NOTICE OF DECISION - AMENDED

Case Number: 18 -15				
Request Type: Site Plan and Special Permit Approval				
Address: 139 Hathaway Road				
Zoning: Mixed Use Business and Industrial B				
Recorded Owner: S.B. Realty Limited Partnership				
Applicant: Paul Bishins, S.B. Realty Limited Partnership				
Applicant Address: 100 North Street, P.O. Box H-3103, New Bedford, MA 02747				
Application Submittal Date		Public Hearing Date		Decision Date
August 13, 2015		September 9, 2015		September 9, 2015
Assessor's Plot Number	Lot Number(s)	Book Number	Page Number	Certificate Number
101	✓ Part 14, 16 & 17, Land Court Lot 11	79	461	✓ 14729

Re: Proposed O'Reilly Auto Parts-Site Plan
139 Hathaway Road
Plat 101 Part Lot 14, 16 and 17 L.C. Lot 11
Case-Number 18-15 Site Plan Approval- Minor Amendment

Request by applicant for **Site Plan** approval for new construction of a 7250 +/- SF retail building, with associated landscaping within the existing property, and **Special Permit** for reduction of parking spaces, located in the Mixed Use Business/Industrial B zoning districts (Attachment 1).

SITE LAYOUT

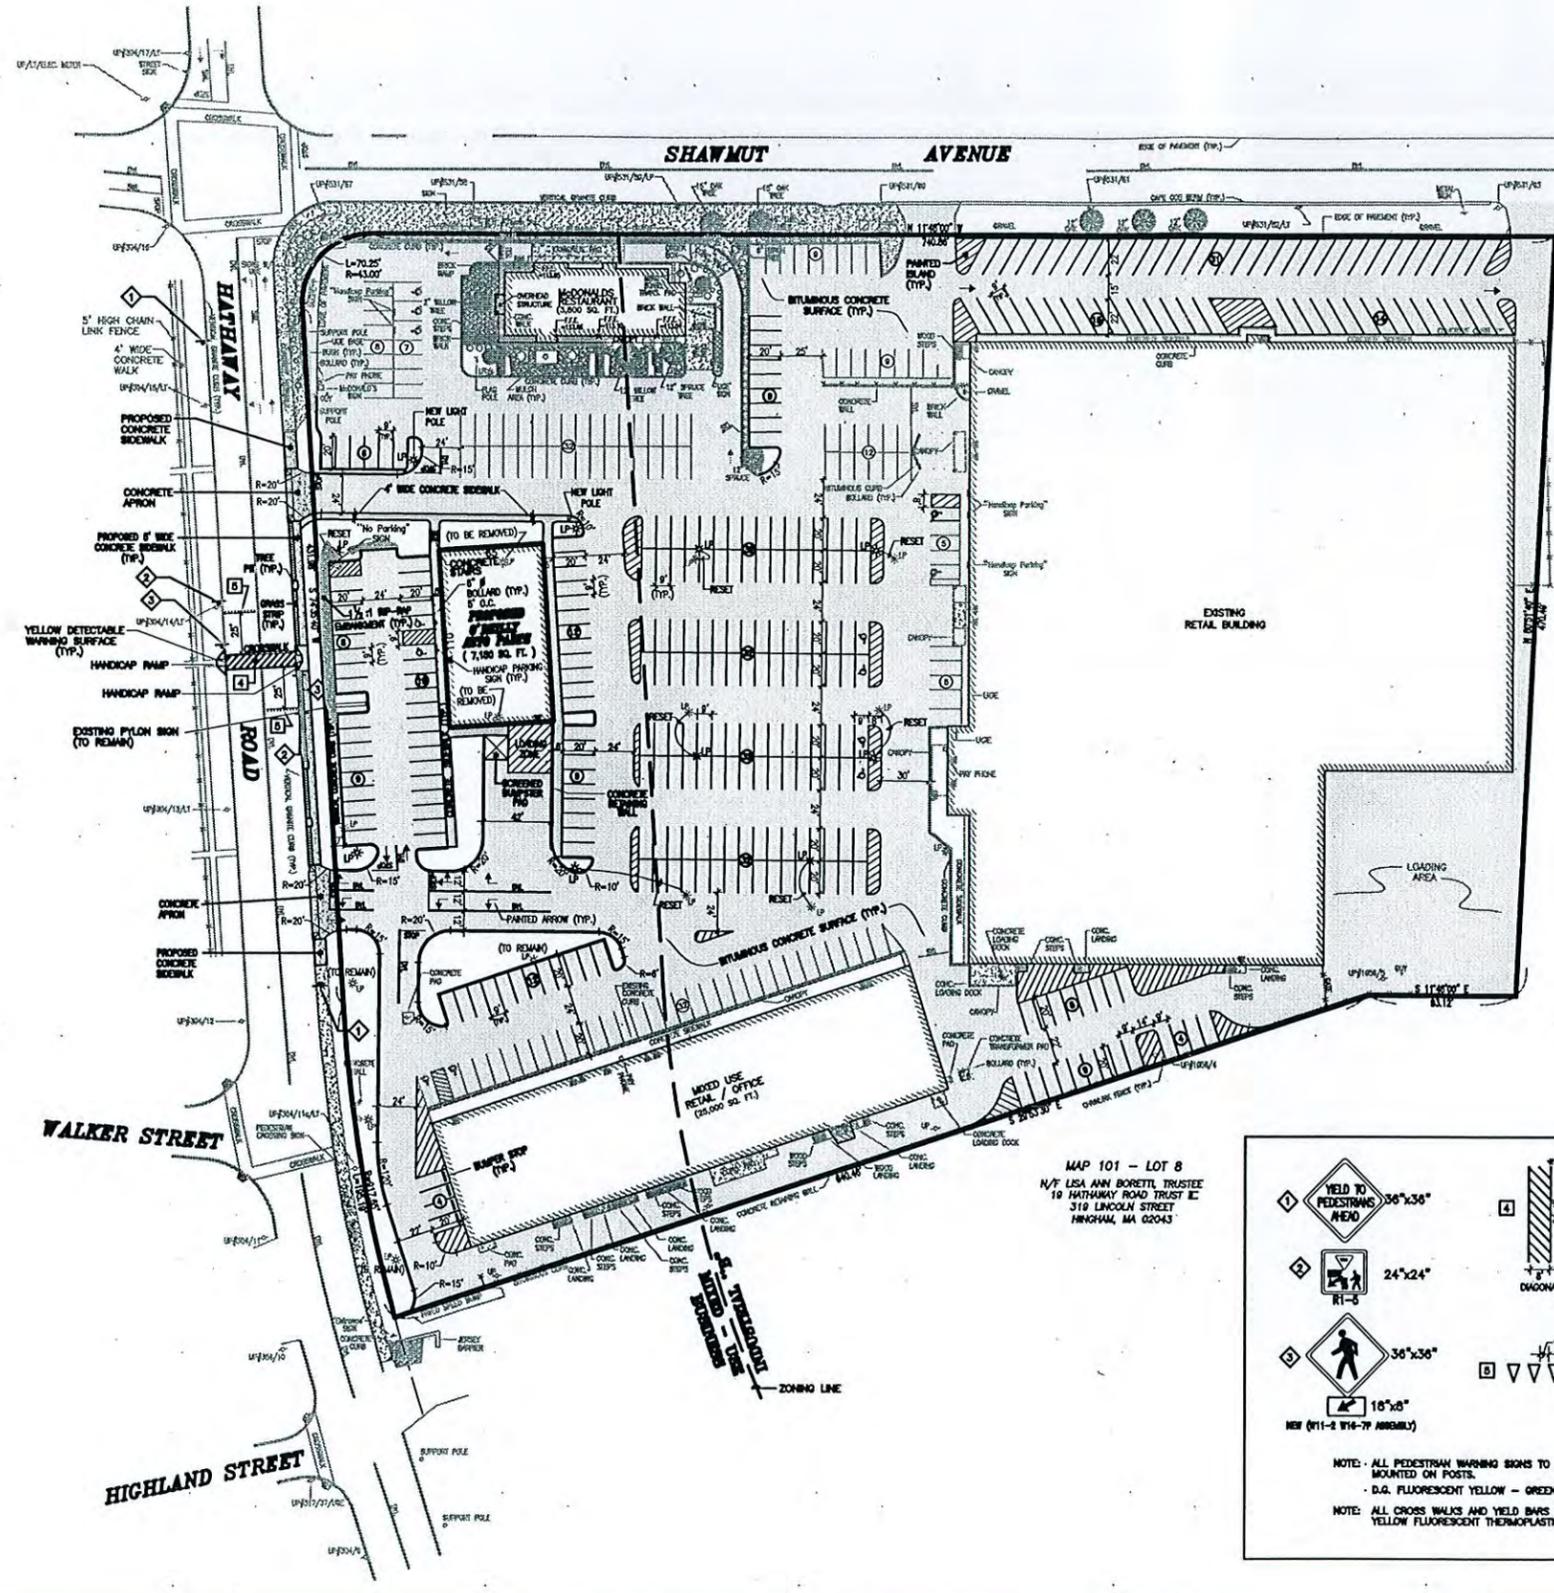
- Parking requirements total 484 spaces, less 50 shared spaces, provide the applicant with 434 parking spaces. According to the applicant's agent, there are 398 spaces. The applicant should seek to amend the Special Permit for parking Reduction in addition to the request for shared parking.

- The number of handicap parking spaces provided are not listed on the Cover Sheet.
- One Loading Zone is shown on the Site Plan, meeting the standards of *one loading space for each building containing more than 5000 SF and less than 10000 SF* and should be included in the Matrix.

The Site Plan illustrates two handicap parking spaces in proximity to the new structure. A perimeter count of the spaces totals 70. Parking and Passenger Loading Zones under 521 CMR stipulates the required number of spaces for 51-75 parking spaces in lot to be three. The applicant should provide evidence that the ADA parking requirements are met as suggested under the Cover Sheet technical review comments (Attachment 4).

If the applicant intends to install a satellite dish, this should be included on a revised Site Plan.

- The Zoning Matrix must be revised.
- The applicant should seek to amend the Special Permit for parking Reduction in addition to the request for shared parking.

- Confirm location of satellite dish, if applicable.
- The applicant should provide evidence that the ADA parking requirements are met as suggested under the Cover Sheet technical review comments.

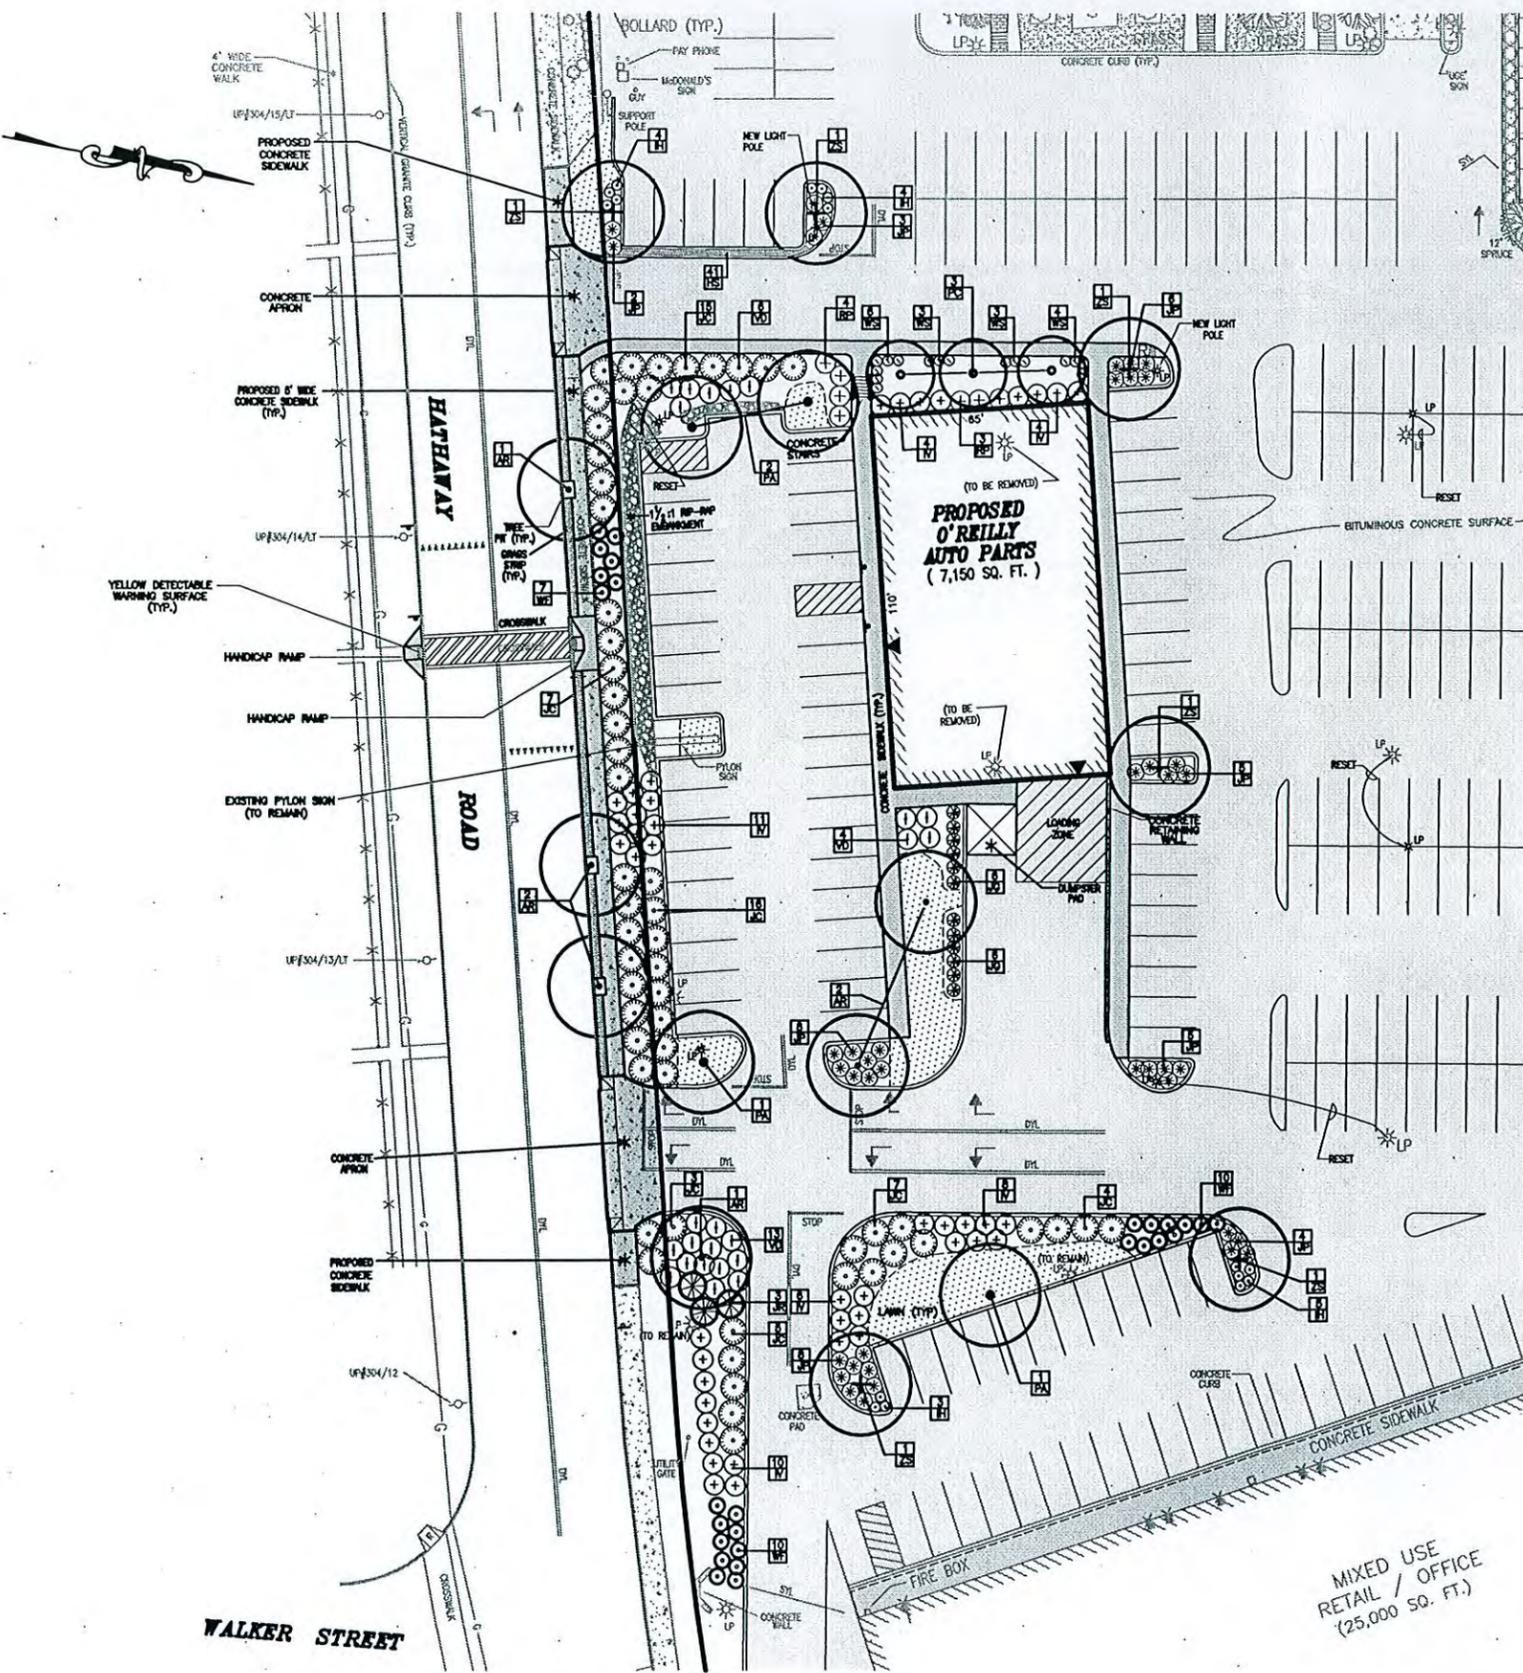
7. The landscaping shall provide trees true to Landscape Plan of 2-2.5 inch caliper diameter at the three-foot rise, or from the top of the burlap and ball.
